SUBJECT: Modification to Multigroup Payload Vehicle Number 2733

1. The attached report is provided in response to TWX WHIG 6280 dated 22 March 1967. This message requested a short paper to serve as a basis for DNRO review of a proposed modification to the third program 770 Multigroup Vehicle No. 2733 (Mission 7163) to increase the probability of intercepting the [redacted] radar [redacted]

COMMENTS ON PROPOSED  
MODIFICATION TO MULTIGROUP  
PAYLOAD VEHICLE  
NUMBER 2733

A REPORT  
PRESENTED IN  
RESPONSE TO TWX WHIG 6280  
DATED 22 MARCH 1967

2733 EFFECTIVENESS AGAINST 1% ON-TIME ABM/AES SIGNAL  
 AS COMPUTED FOR DAVIS COMMITTEE.  
 (5 PULSES ON EACH OF 3 FREQUENCY INTERCEPTS, SLOW SCAN)

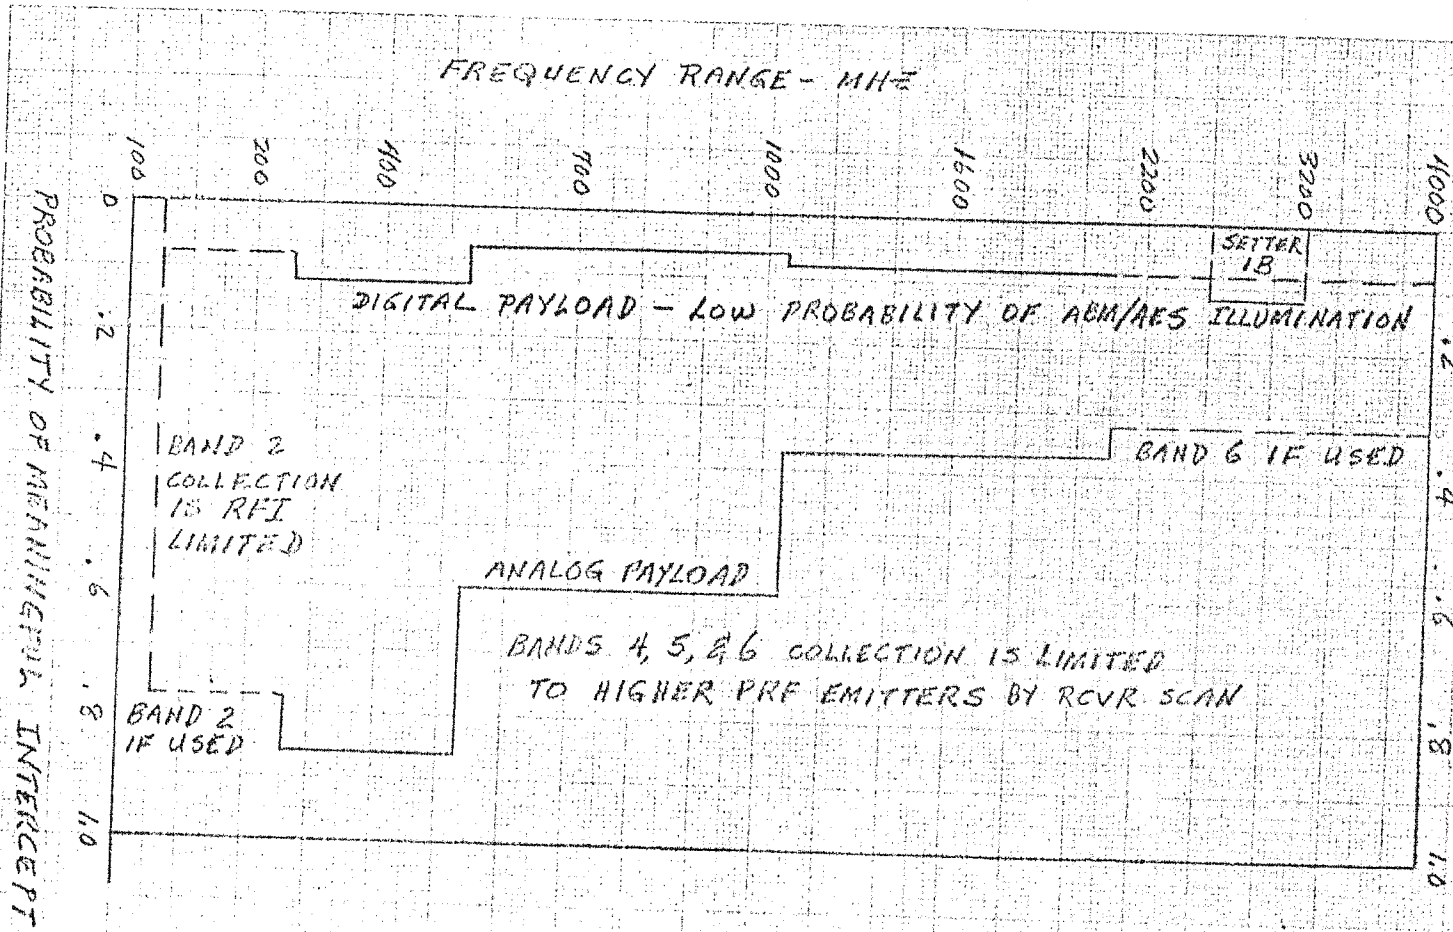
With the exception of the ABM/AES P-11's, the Davis Committee evaluation showed that the Multigroup systems were the major contributors to the ABM/AES search mission. The 2733 intercept probability spectrum is shown in the following chart. The analog payload has a 97% probability of illumination over its first two months. Hence, the probability for the elliptical orbit is only 3% better than shown. The improved probability of either system with wide-pulse recognizers or a reduced scan rate in the PRF limited higher bands would swamp the other differences between them in terms of improving the probability of ABM/AES intercept.

PV 233 PROPOSED CONFIGURATION

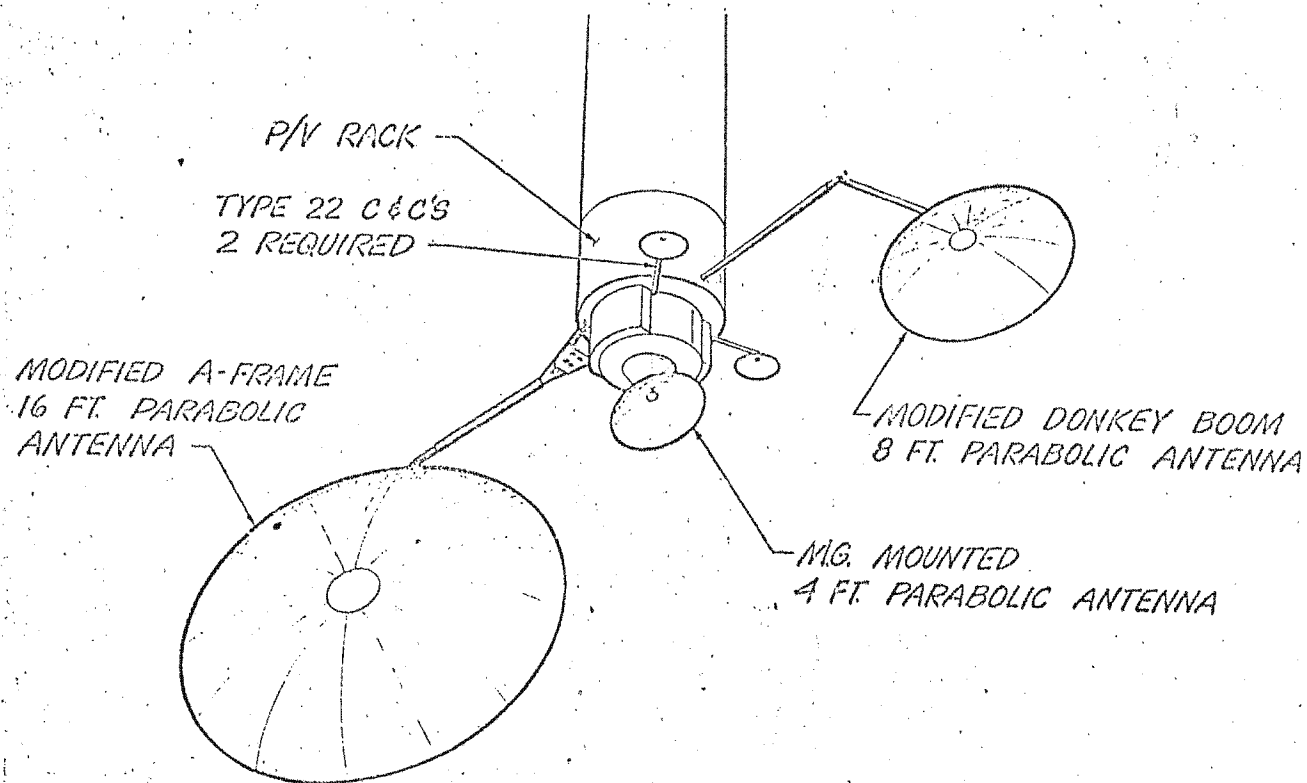
Modification to the 2733 vehicle consists of the following changes:

Removals

Multigroup antenna deck  
 Lo-band antenna  
 Setter payload  
 WECO/BTL radio guidance system

Equipments to be modified

Multigroup payload  
 Structure and antenna booms  
 Stored and real time command systems; including Fairchild  
 timer modification to increased period  
 Ascent guidance system  
 Telemetry system  
 Solar array panel assemblies

New equipments to be added

Recognizer capability on all bands  
 Redundant analog recorder (DSU)  
 Antennas (3)  
 Antenna drive motors, steering electronics, and command  
 system  
 Closed-loop CMG torquer controls  
 Additional pyro J-box and circuitry

A picture of the modified payload vehicle is provided on the next page.

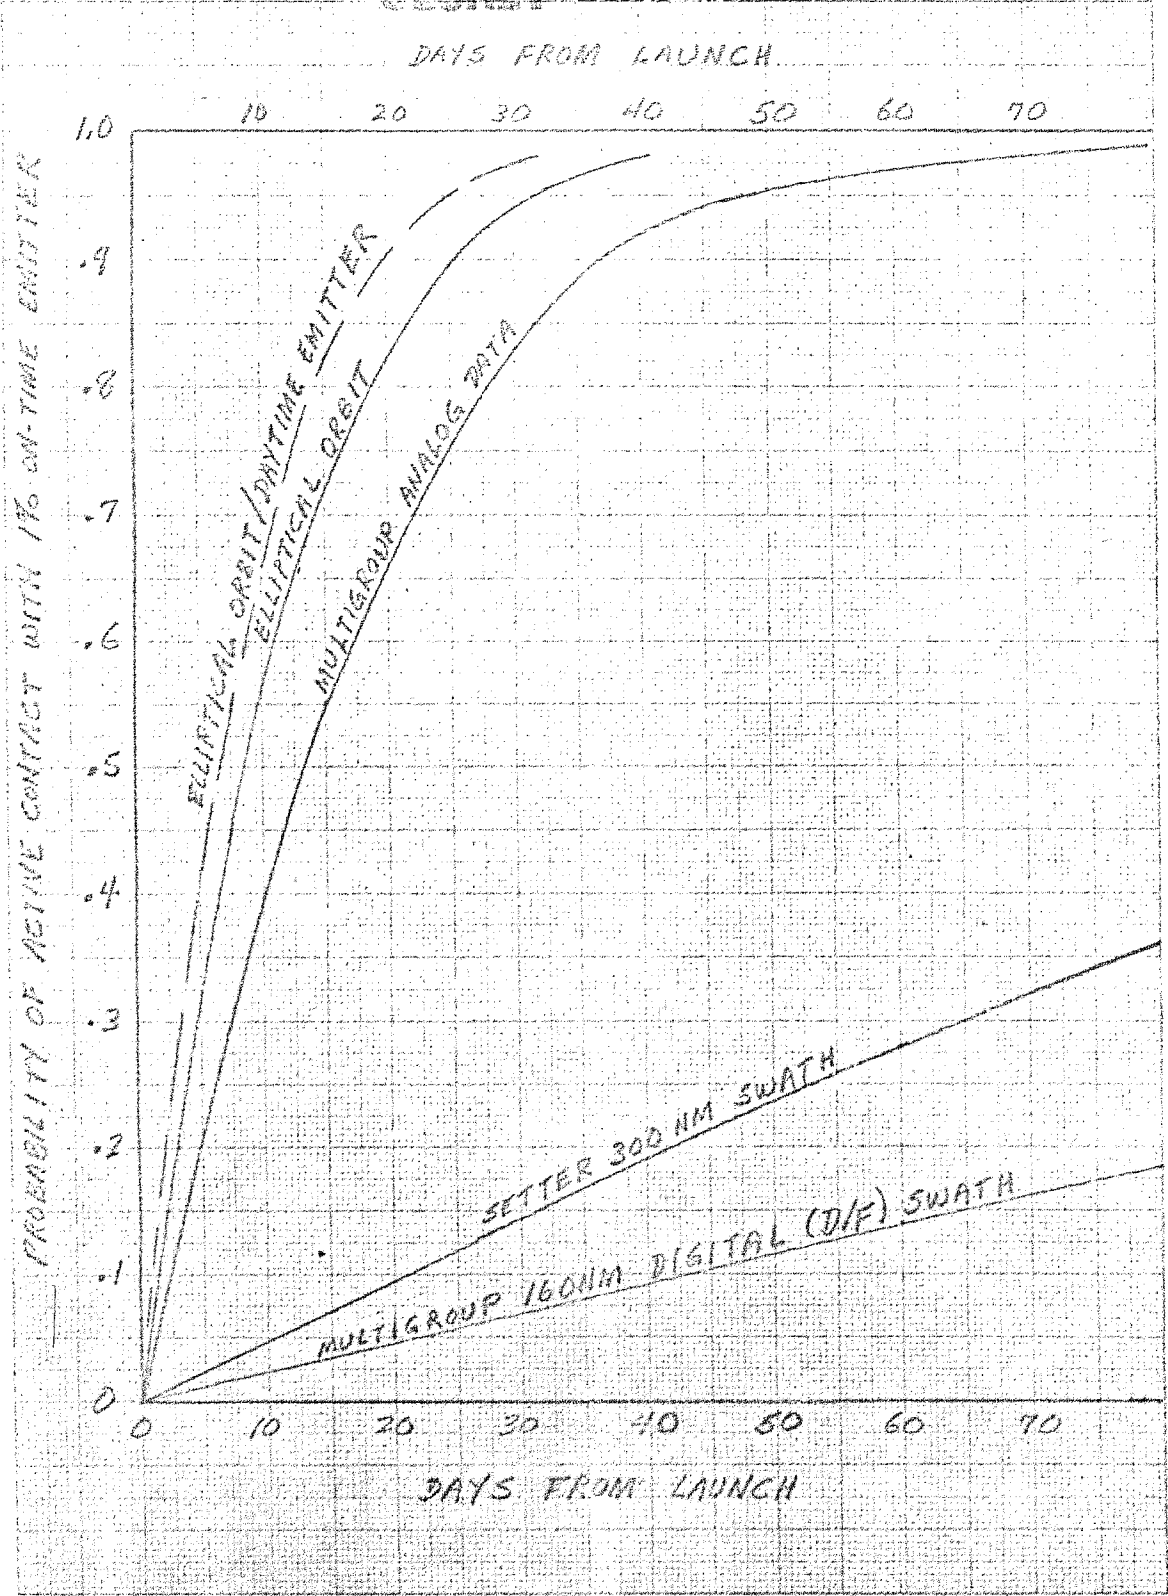
Using standard statistical techniques, we can relate the number of looks per day to a probability of illumination as a function of time. This function is shown in the following graph. Since the elliptical orbit is nearly sun synchronous, its coverage can be centered around daytime coverage; but, since it makes contact on eight out of its 10 revs each day, this is not a big advantage. The plot shows the probability gain due to this if we assume daytime emitter operation. It can be shown that, since the low altitude orbit will spread its samples throughout the day over each 30 day period (90° nodal rotation), it does not suffer a penalty (on average) due to the assumption of daytime operation.

The curves show that the elliptical orbit has a 2:1 advantage over the normal Multigroup orbit against [redacted] but that either system has almost unity probability of intercepting the 1% on-time emitter during its nominal two months' life. As long as the emitter on-time is low, the probability of ABM/AES intercept in the low altitude digital payloads is low. However, these intercepts will produce a 10-100 NM emitter position estimate if they occur. The geoposition accuracy from the elliptical orbit is 200-2000 NM depending on the intercept, geometry and frequency.

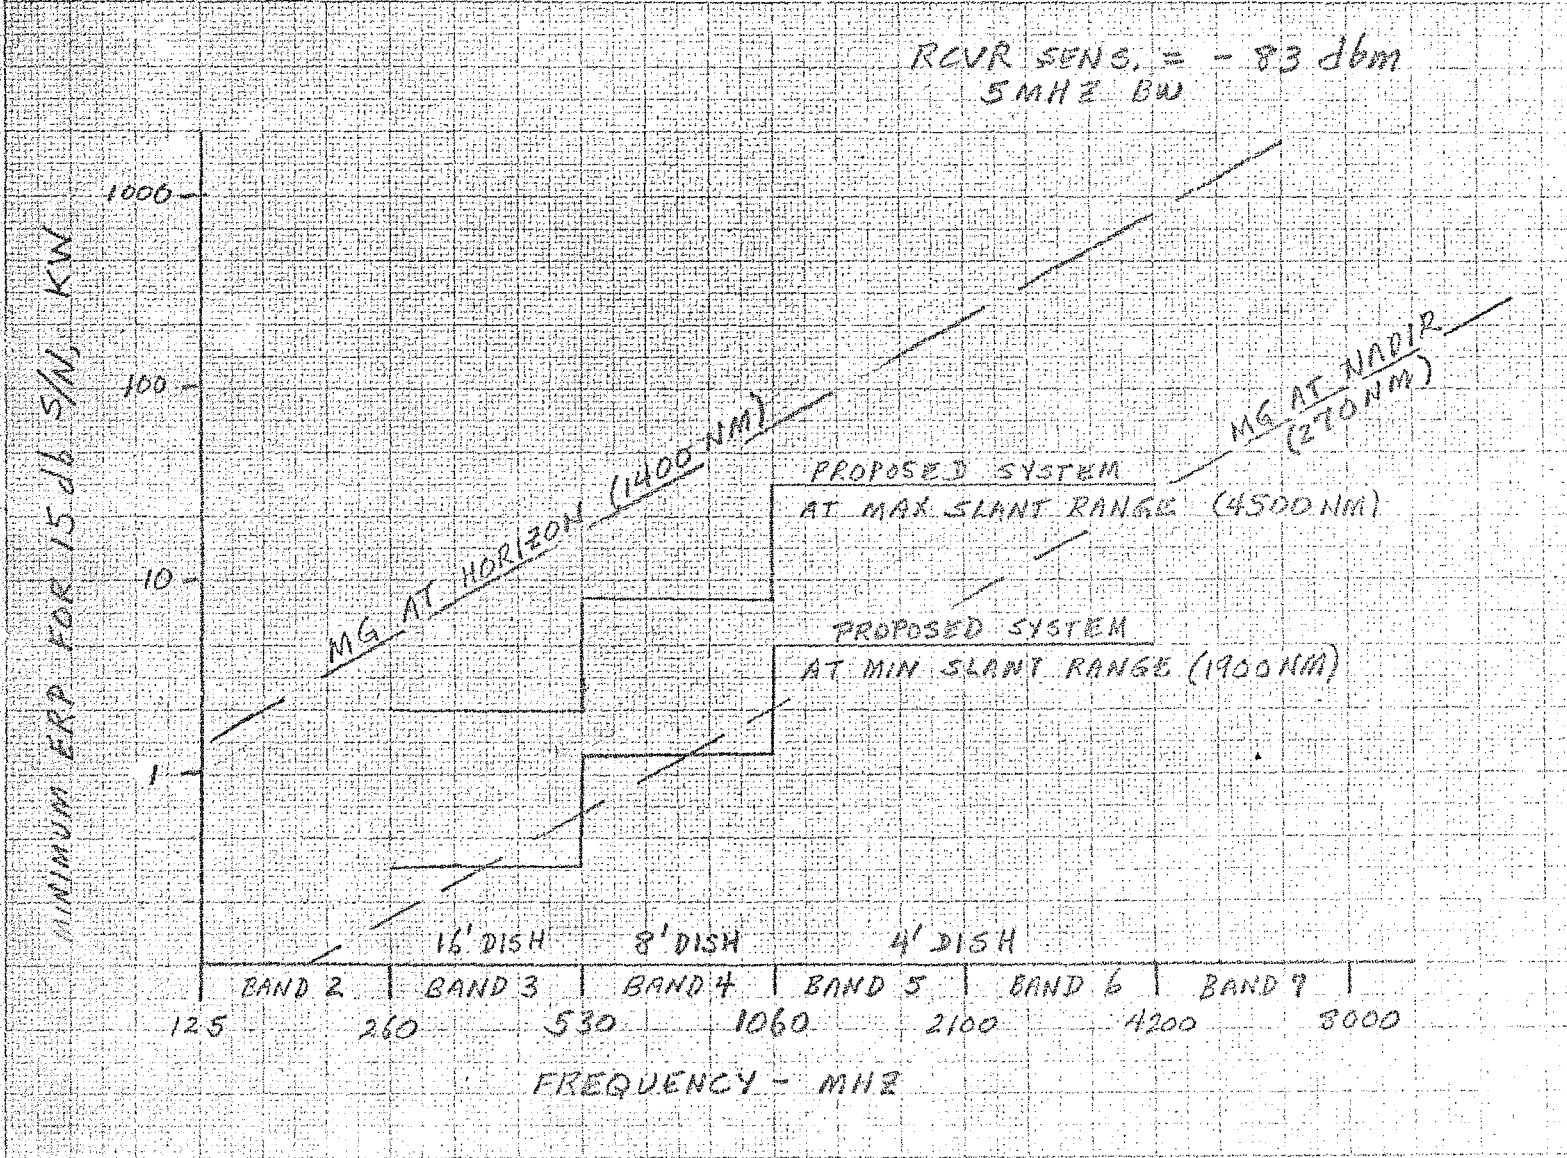
The only remaining evaluation parameter is the minimum power which the payload can intercept. This is compared in the following chart. It can be seen that the systems are very nearly equivalent in their ability to collect weak signals.

Thus, it appears that the only significant argument in favor of the elliptical orbit is its 2:1 advantage in probability of [redacted]
